PERMIT CHANGE TRACKING FORM

DATE RECEIVED	PERMIT NUMBER <i>ACT/007/018</i>
Title of Proposal: <i>Midterm Revision</i>	PERMIT CHANGE # <i>94B</i>
Description:	PERMITTEE <i>Soldier Creek Coal Co.</i>
	MINE NAME <i>Soldier Creek</i>

Re: Mid-Term Review
Soldier Creek Coal Company

Re: Midterm Response Review, Soldier Creek Coal Company, Soldier Canyon Mine, ACT/007/018-94B, Folder #3, Carbon County, Utah

FIGURE 7.24-7
Water Level Vs. Time Plot

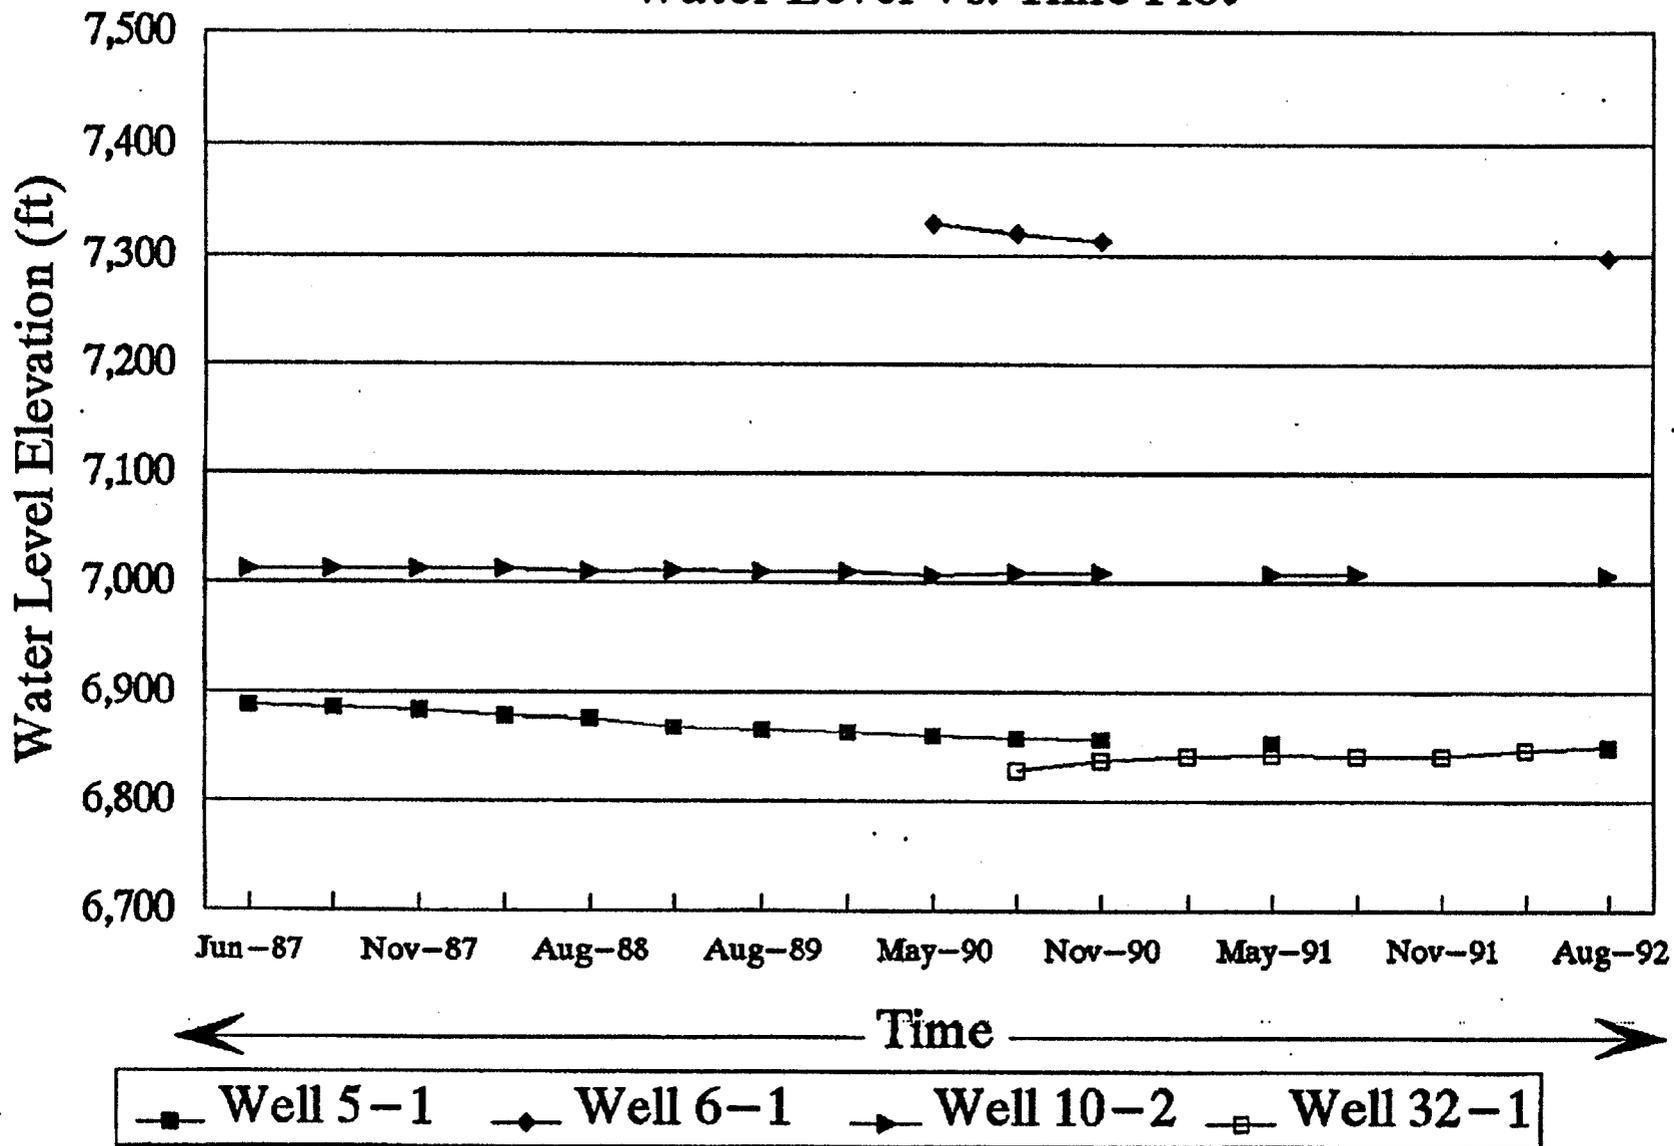
10. *The figure heading in Figure 7.24.7, incorrectly describes the information presented. The Operator provides the depth to water from the well casings not the water level elevation as indicated. Because the elevations have no relative base elevation the presentation of data is unclear. The Operator has not met the requirements of R645-301-121.*

8. *The figure heading, in Figure 7.24.7, incorrectly describes the information presented. The Permittee provides the depth to water from the well casings not the water level elevation as indicated. Because the elevations have no relative base elevation the presentation of data is*

information on Figure 7.24.7. The label incorrectly describes the information presented. The Operator provides the depth to water from the well casings **not** the water level elevation. Because the elevations have no relative base elevation, the presentation of data is misleading.

8. The figure heading, in Figure 7.24.7, incorrectly describes the information presented. The Operator provides the depth to water from the well casings not the water level elevation as indicated. Because the elevations have no relative base elevation the presentation of data is unclear. The Operator has not met the requirements of R645-301-121.

Response: We have enclosed a revised Figure 7.24.7

The Permittee has enclosed a revised Figure 7.24.7. This figure more accurately represents the well elevation. The Permittee has presented the wells with a relative base elevation.

FIGURE 7.31-9
SAMPLE SITE WELL 6-1

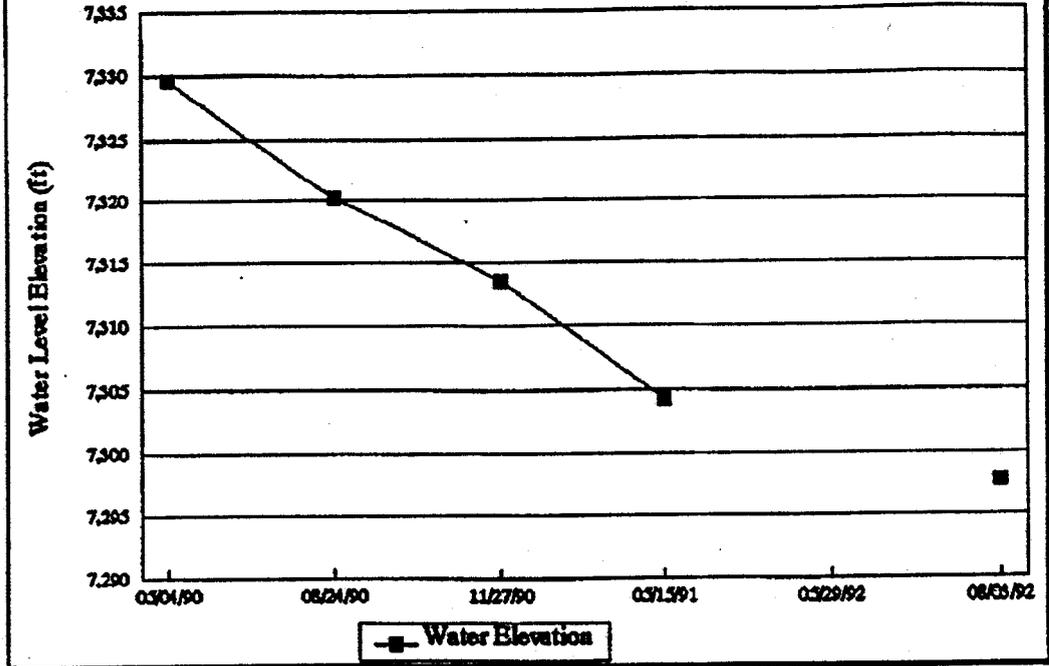
9. *The Operator has provided Figure 7.31-9 for Well 6-1. The scale used to present the information is inadequate. The Operator should present a scale in feet rather than thousands of feet to provide a clear figure per R645-301-121.*

7. *The Permittee has provided Figure 7.31-9 for Well 6-1. The scale used to present the information is inadequate. The Permittee should present a scale in feet rather than thousands of feet to provide a clear figure per R645-301-121.*

The Operator has provided Figure 7.31-9 for well 6-1. The scale used to present the information is inadequate. The Operator should present a scale in feet rather than thousands of feet. The Operator shows additional well

7. The Operator has provided Figure 7.31-9 for Well 6-1. The scale used to present the information is inadequate. The Operator should present a scale in feet rather than thousands of feet to provide a clear figure per R645-301-121.

Response: We have enclosed a revised Figure 7.31-9.

The Permittee has enclosed a revised Figure 7.31-9. This figure more accurately represents the well water elevations. The Permittee has presented a scale of 5 feet per tick mark.
